**Permit Application Review Report**  
**Date: 4/22/2026**

**Project Name:** Costco Fuel Facility Relocation

**Project PAN:** P-26-002

**Project Purpose:** fuel facility decommission and relocation with associated stormwater treatment and minor drive aisle adjustment

# Figure 2: Site Plan

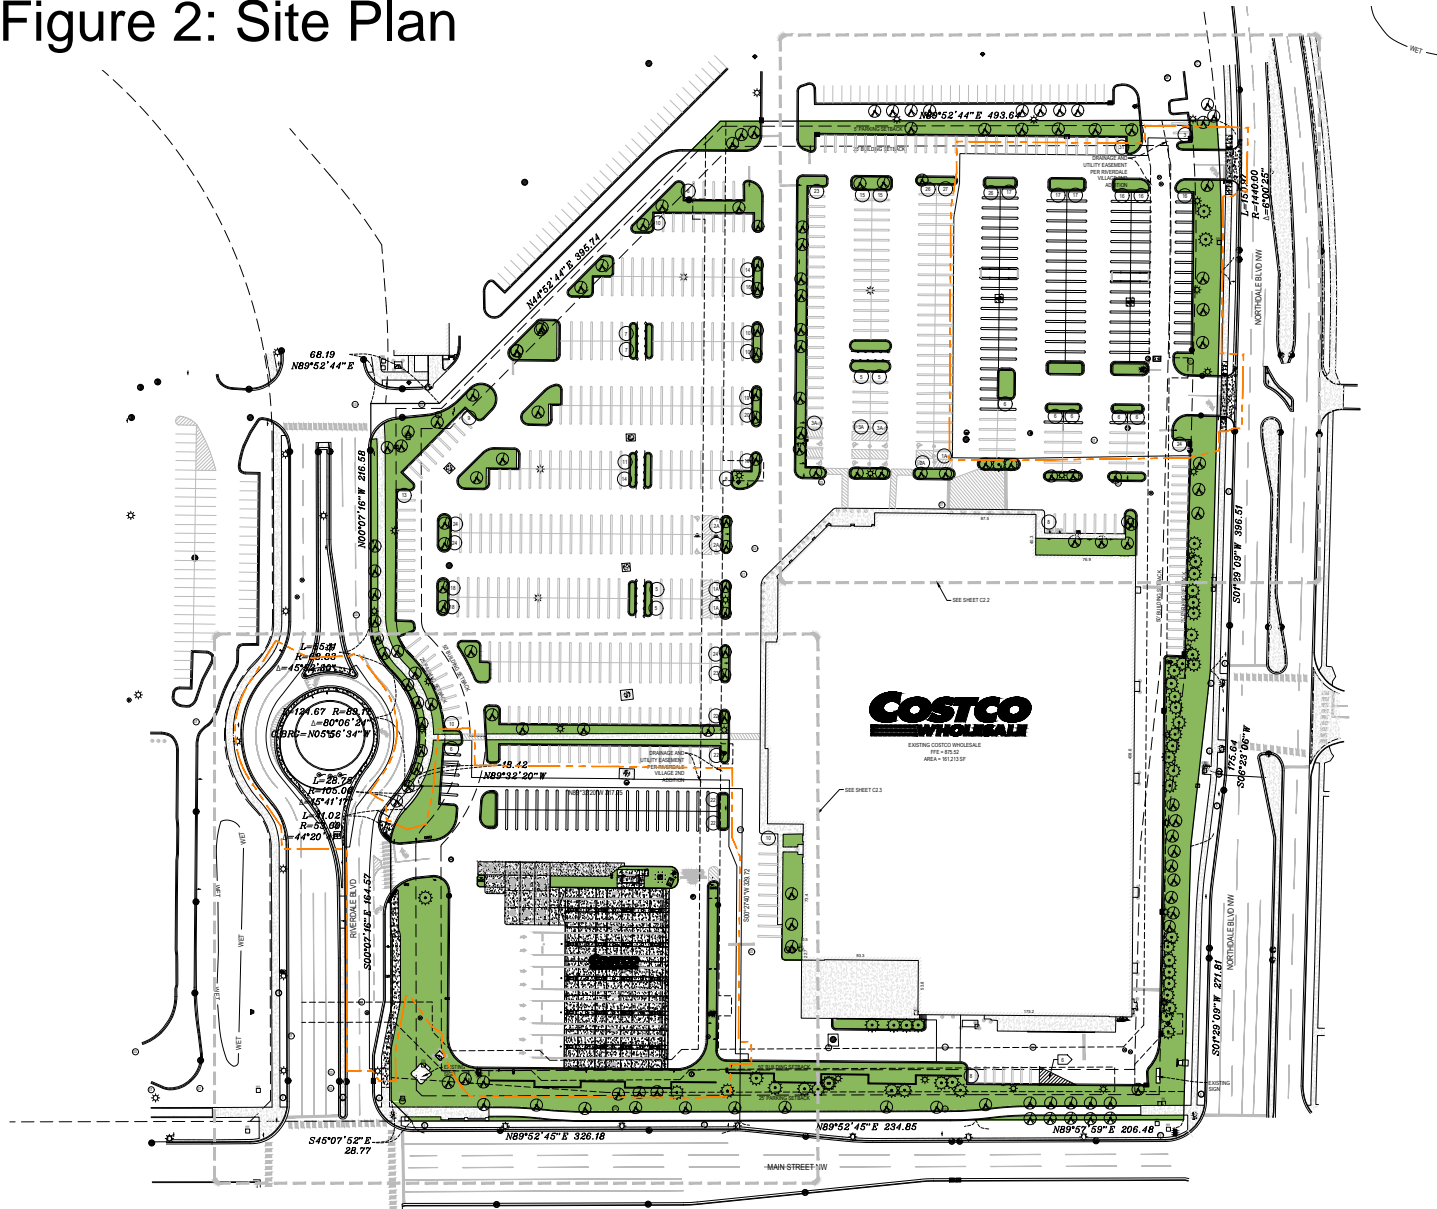
3. Update the erosion control plan to include the following:
  - a. a note to stabilize soils and soil stockpiles within 7 days of inactivity.
  - b. standard details for inlet protection and concrete washout station.

c. a note that streets will be swept clear of sediment by the end of each work day.

The proposed project drains to Ditch 54. The soils affected by the project include Urban and do not have a soil erodibility factor of 0.15 or greater. Disturbed areas are not proposed to be stabilized within 7 days, as required. The proposed erosion and sediment control plan includes inlet protection, stabilized construction entrance and perimeter control. The erosion control plan does not meet District Requirements because soils and soil stockpiles are not proposed to be stabilized within 7 days of inactivity, inlet protection and concrete washout station details have not been provided, and streets are not proposed to be swept by the end of the workday. The site does require an NPDES permit. See Figure 3: Soils and Erosion Control.
